MEMORANDUM

RE: Planning Department Recommendations (Revised)

Please find attached, for your information, Planning Department recommendations for the April 7, 2026 Board of Appeals Hearing.

65 to 79 Wareham ST 08 Roxbury MA 02118
52 Plympton ST 08 Roxbury MA 02118

Appendix B
Exhibit B "Open Space Plan"

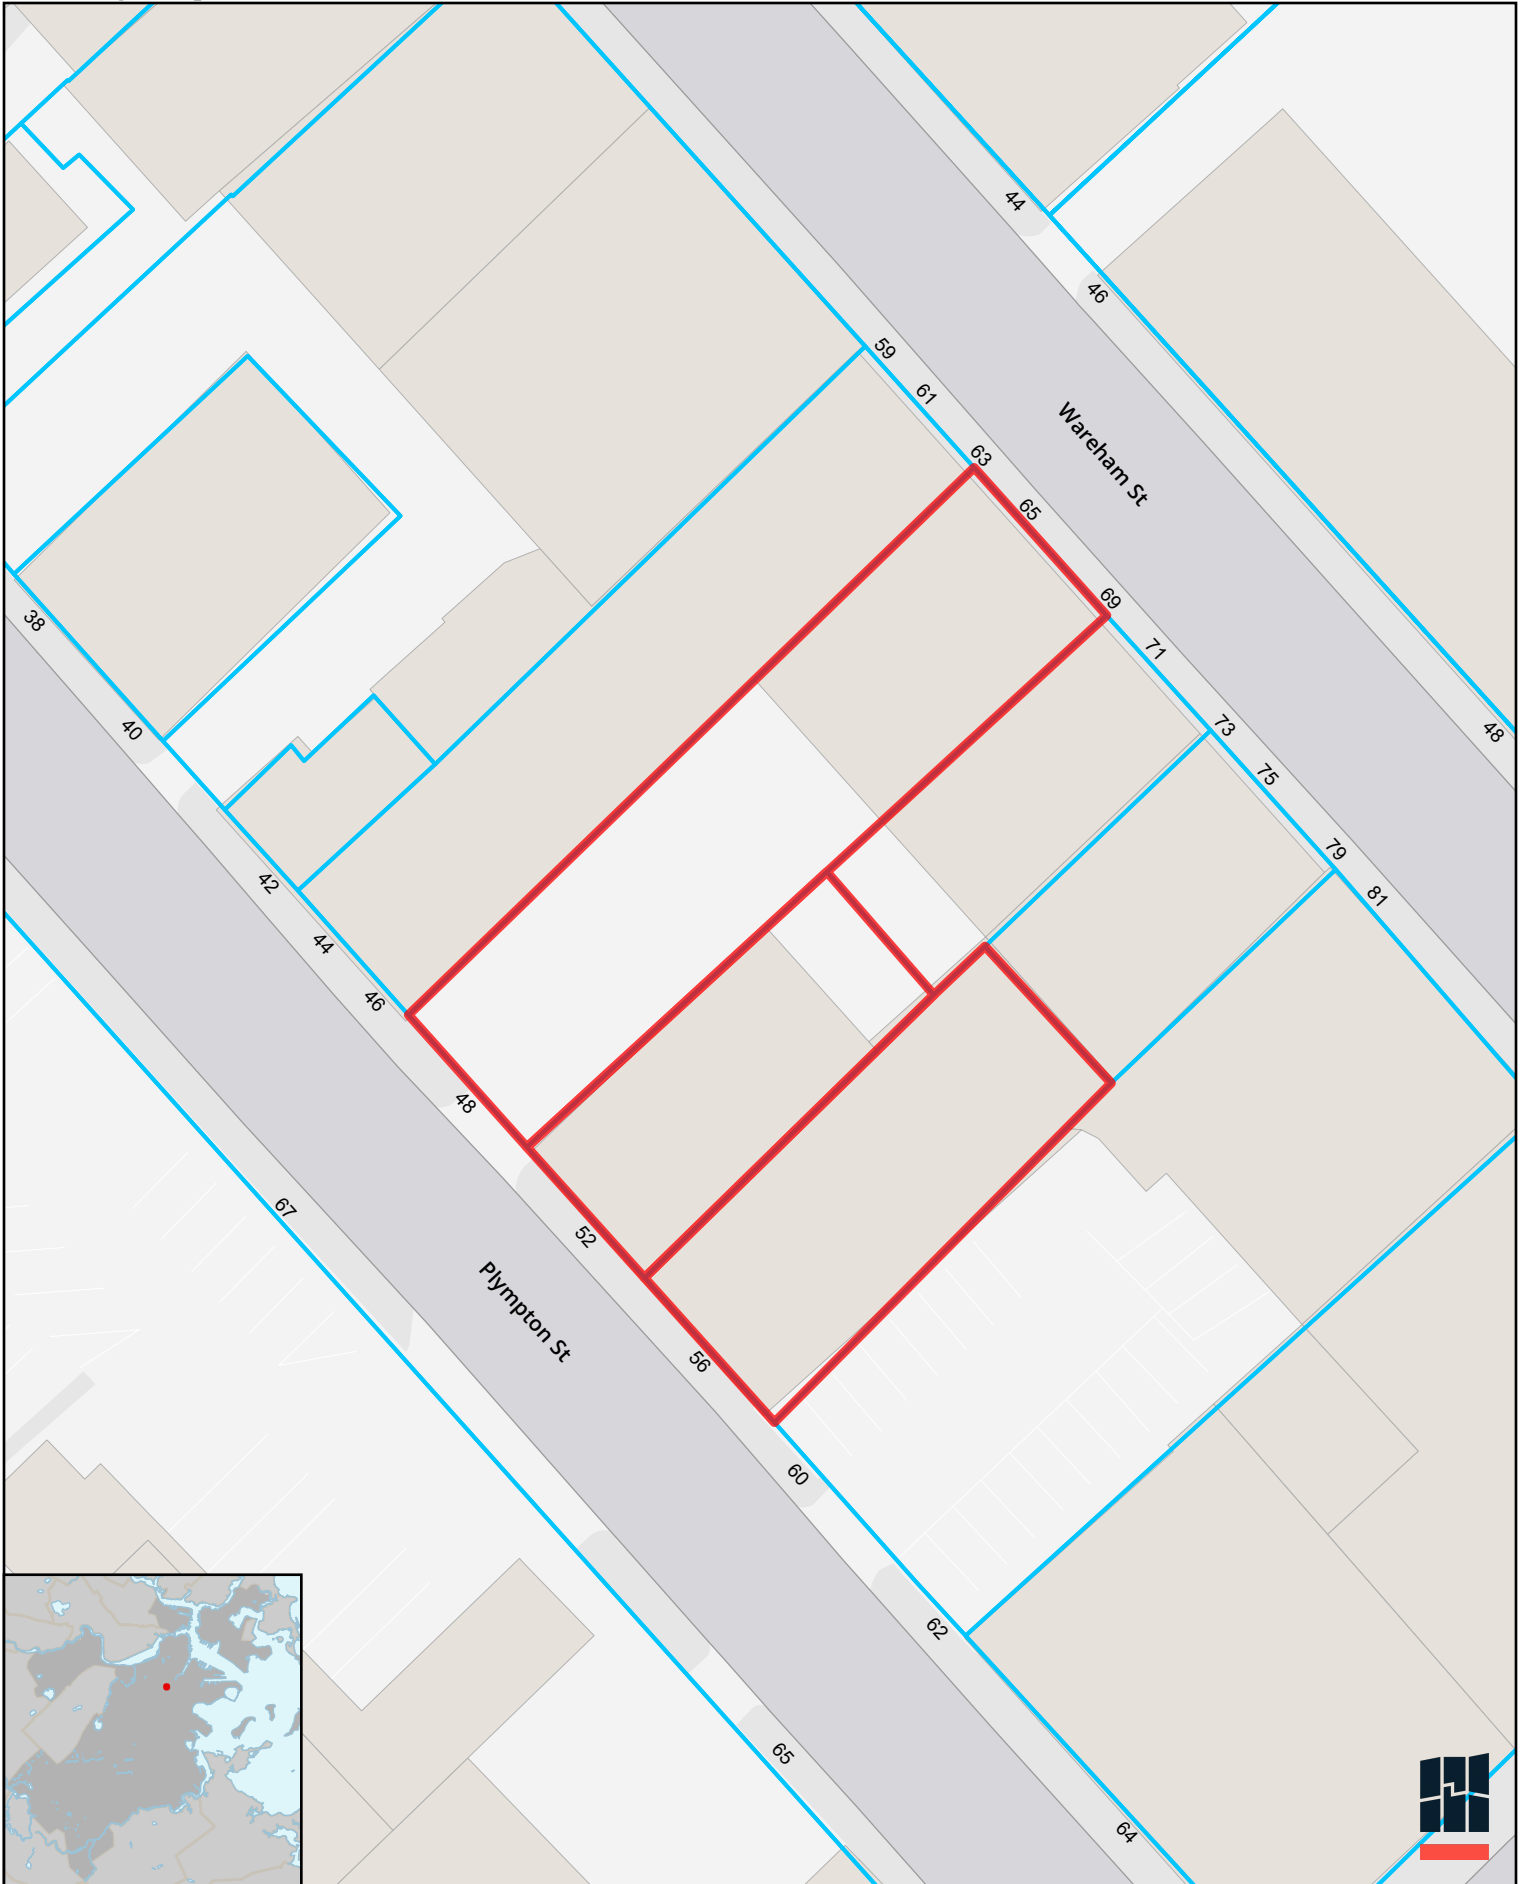
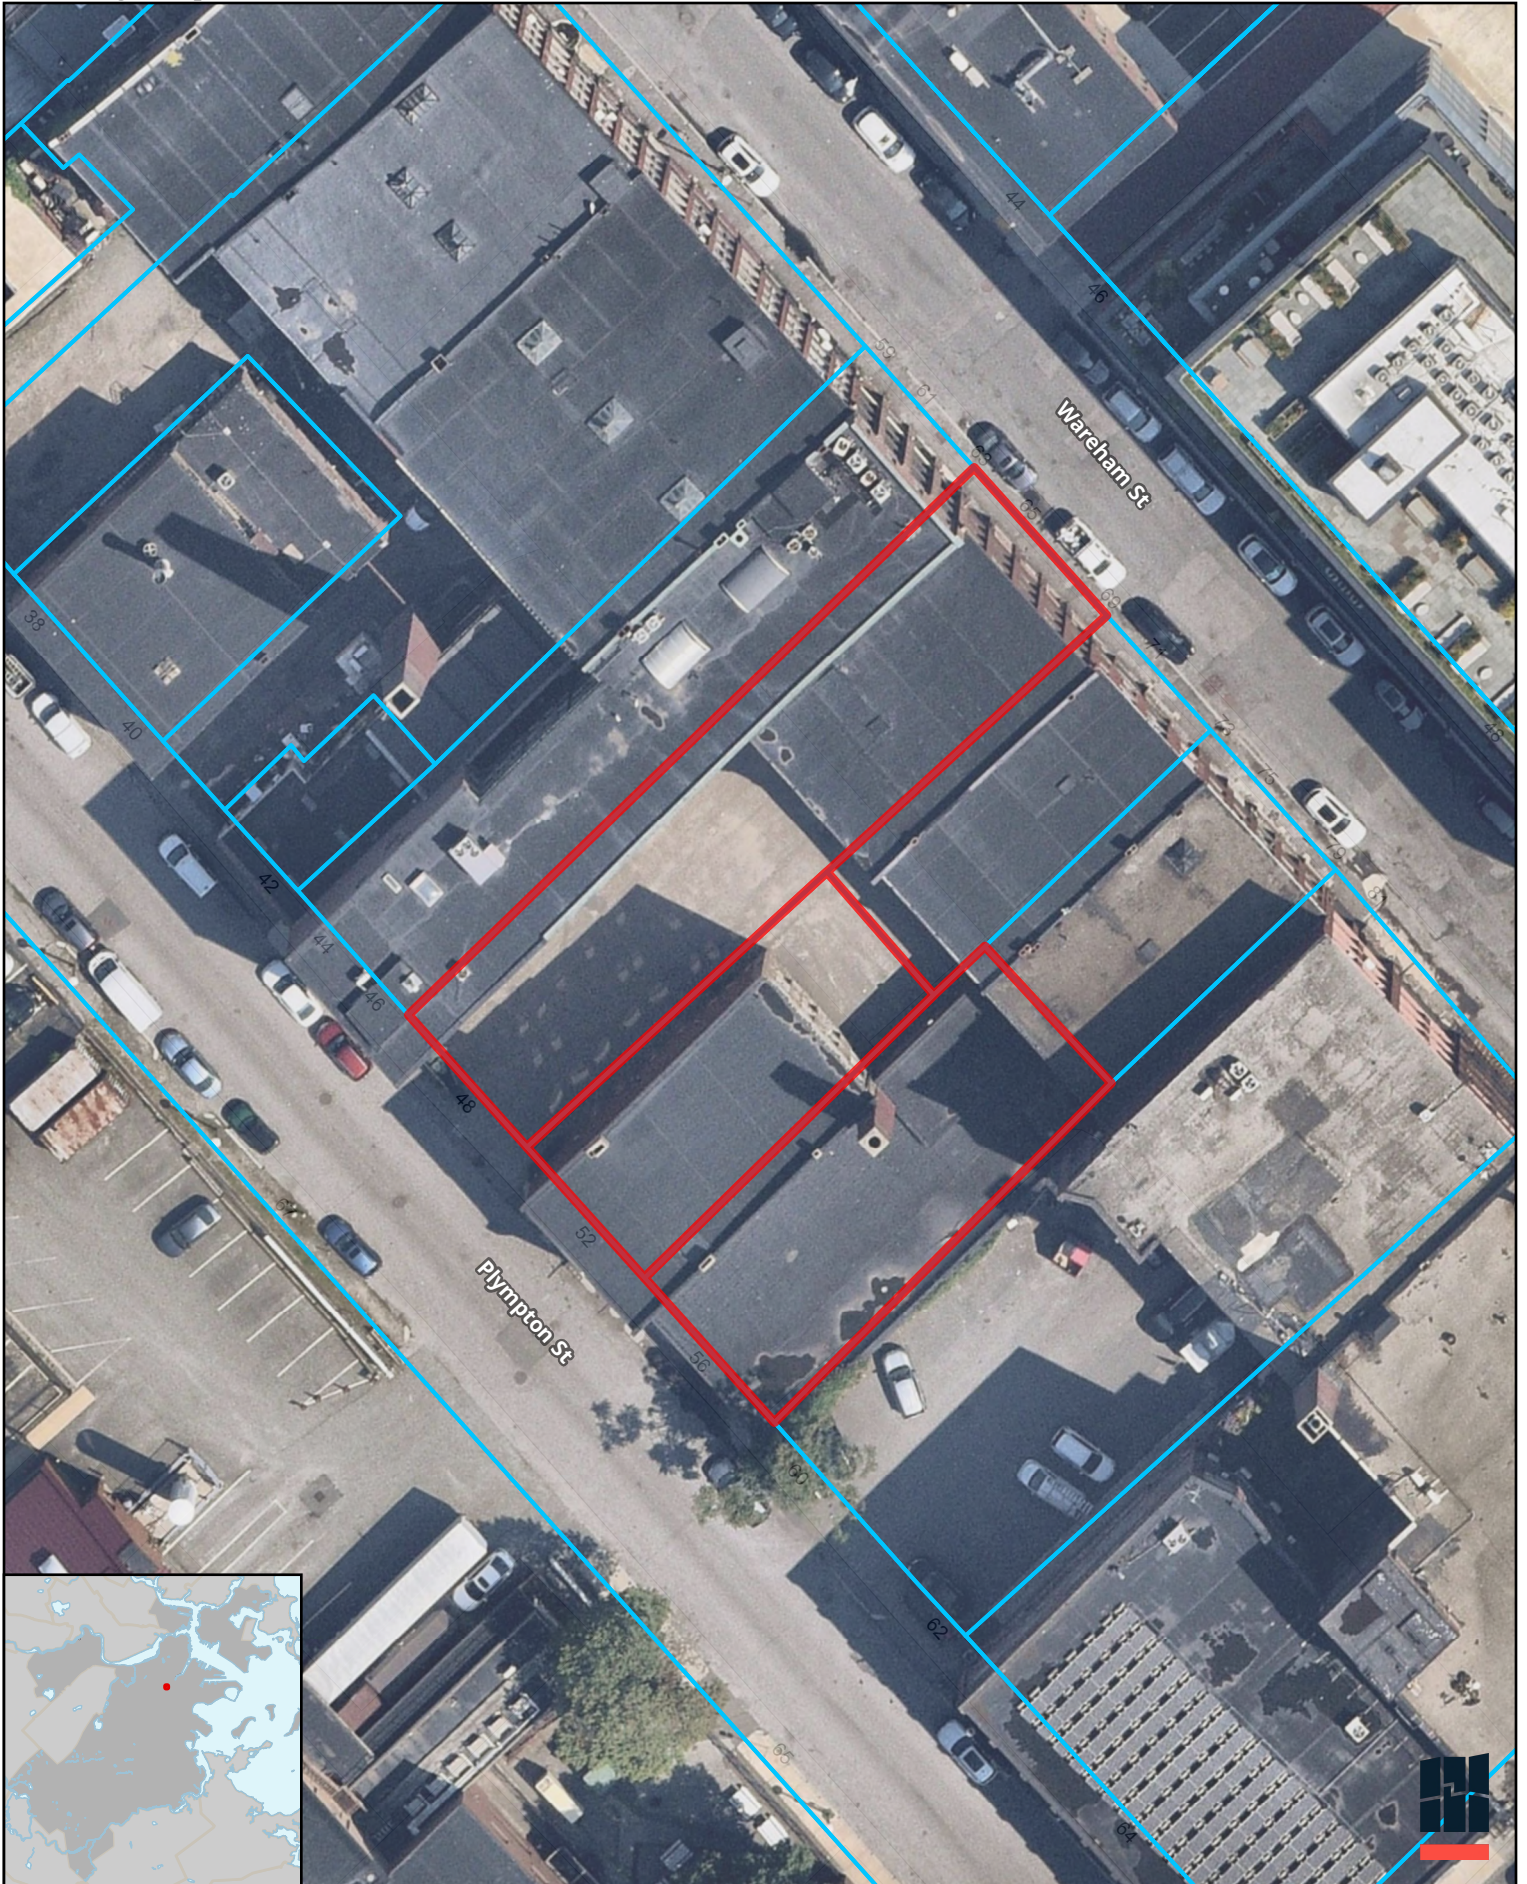
- 1. Redesign the parking configuration to achieve compliance with CFROD resiliency requirements & guidelines. Below-grade, dry floodproofed residential-use parking is not supported per FEMA, NFIP, and ASCE guidance**
 - a. Possible design solutions to this issue include:
 - i. Changing the garage use to be mixed use
 - ii. Raising the parking level to be at-grade
 - iii. Removing the parking
- 2. Redesign the entry so the ADA accessible entrance is located at the primary entrance of the building**
 - a. The Planning Department recommends consolidating the ADA and primary entrances so that the front door access from the stairs and ramp face the street.
- 3. Increasing the width of the proposed ROW by 4” to achieve minimum required dimensions**
 - a. A minimum 5’ pedestrian path and 3’ furnishing/planting zone is required. See Pedestrian Zone Feedback for explanation and proposed options

- a. In order to achieve the necessary dimensions for *minimally* compliant sidewalks (5' pedestrian path w/3' furnishing zones), the Planning Department recommends that the proponent team consider the following options:
 - i. Shift the proposed curb alignment further into the existing right of way and consider the implications that may have for the proposed streetscape design

- ii. Shift the ground floor of the project 4” off the property line in order to achieve the necessary 5’ pedestrian path and 3’ furnishing zones. Planning staff is not recommending the proponent shift the overall massing 4” back from the property line, only the ground floor.
